# UNITED STATES PATENT AND TRADEMARK OFFICE

09/977,197

NGUYEN, LAM S

<b>Office Action Summary</b>	<b>Application No.</b>	<b>Applicant(s)</b>	
	09/977,197	SHIMADA ET AL.	
	<b>Examiner</b>	<b>Art Unit</b>	
	LAM S NGUYEN	2853

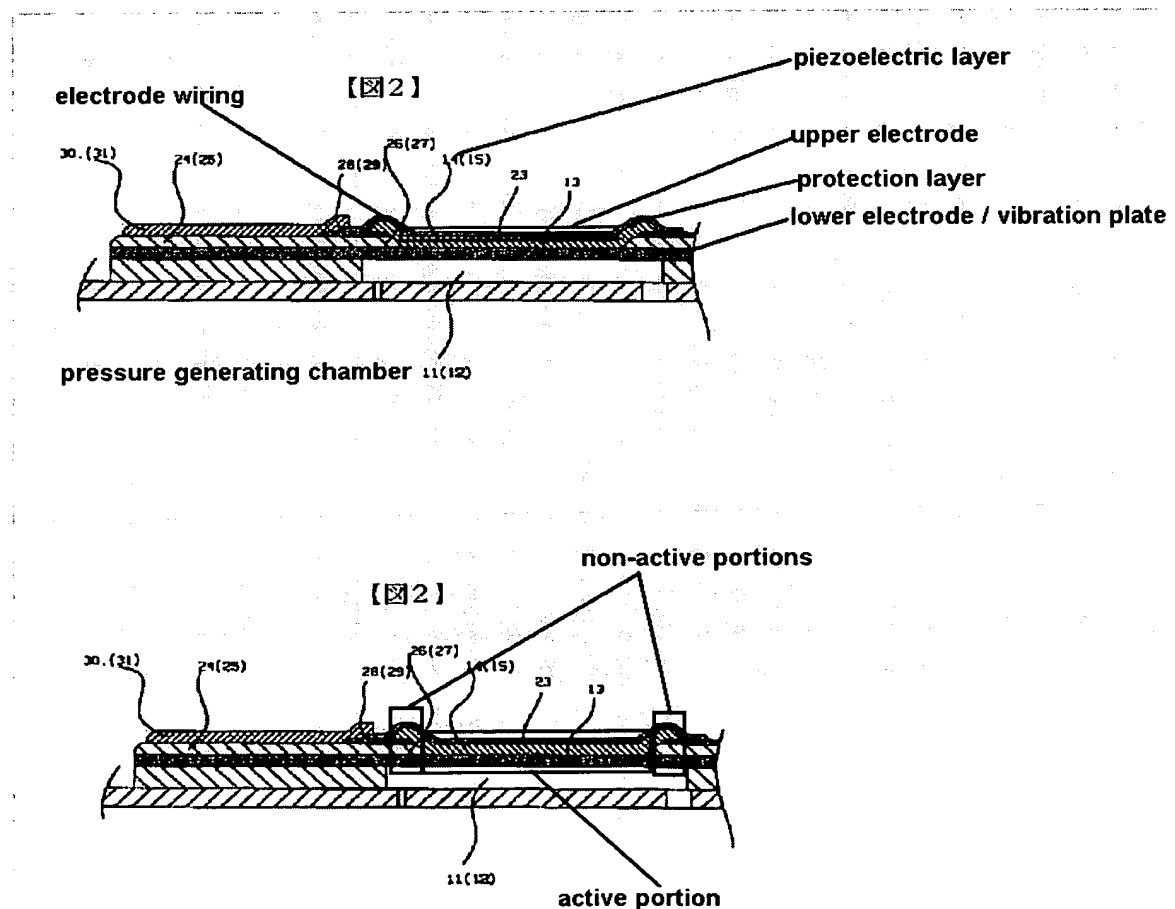
Claims 1, 5-8, 10, 11, 15, 20, 21/(1, 5-8, 10, 11, 15, 20), 23, 24 are rejected under 35 U.S.C. 102(b) as being anticipated by Katakura (JP 11-70654).

Katakura discloses all features of the claimed invention as clearly illustrated below.

The applicants argued that the alleged electrode wiring of Katakura is not drawn out from the alleged upper electrode. The examiner does not agree. As shown in FIG. 2 above, it is clear that the electrode wiring is drawn from at one end of the upper electrode at which the piezoelectric is non-active. In addition, the applicants argued that the electrode wiring and the upper electrode are two separate elements. However, the claimed language of claim 1 does not define the separation of the electrode wiring and the upper electrode.

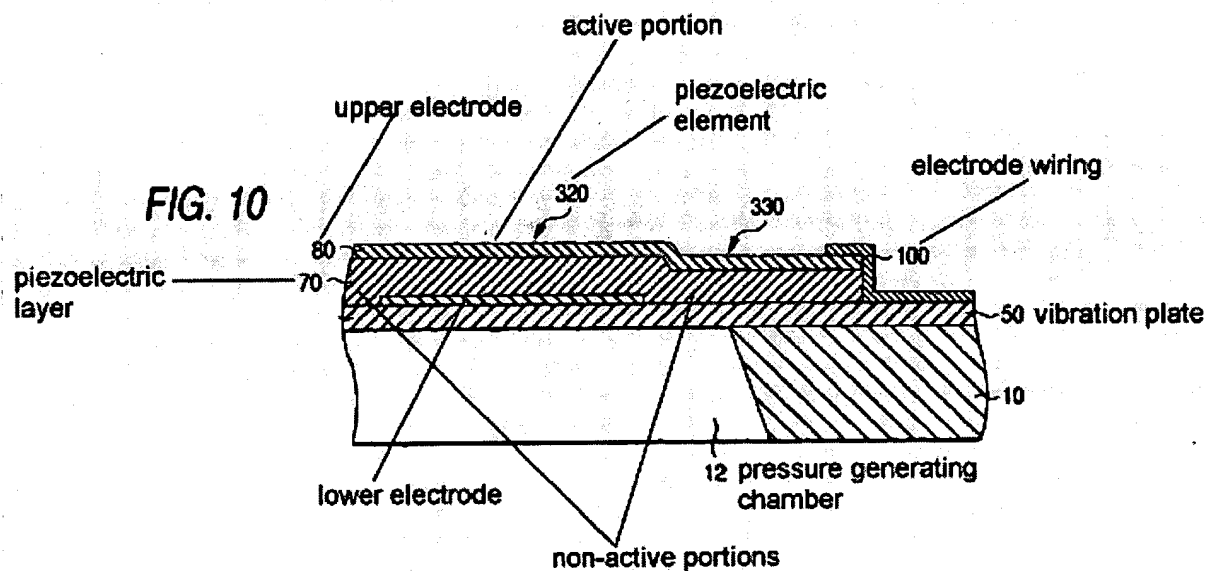
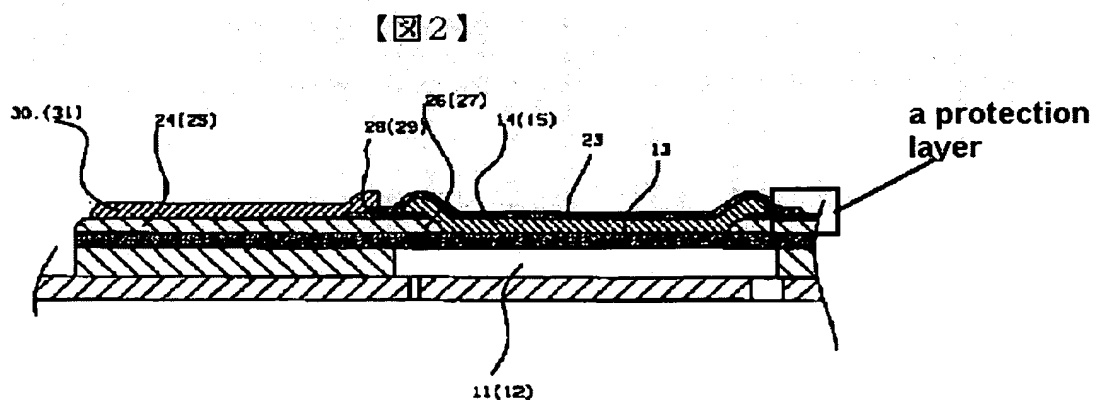
Shimada et al discloses all features of the claimed invention except for a protection layer being provided only on/in the other end portion, the protection layer possesses with higher rigidity than the lower electrode, and a tip portion of the protection layer

having a triangular shape. See particularly column 17, lines 11-15, column 18, paragraph [0147] and the illustration below for the major elements of the claimed invention.

However, Katakura discloses a protection layer only on/in one-end portion as clearly illustrated below. The protection layer illustrated below possesses higher rigidity than the lower electrode [13] because the protection layer is thicker than the lower electrode.

It would have been obvious to one having ordinary skill in the art at the time the invention was made to include the protection layer as taught by Katakura in the teaching of Shimada et al for the purpose of preventing crack on a piezoelectric element.
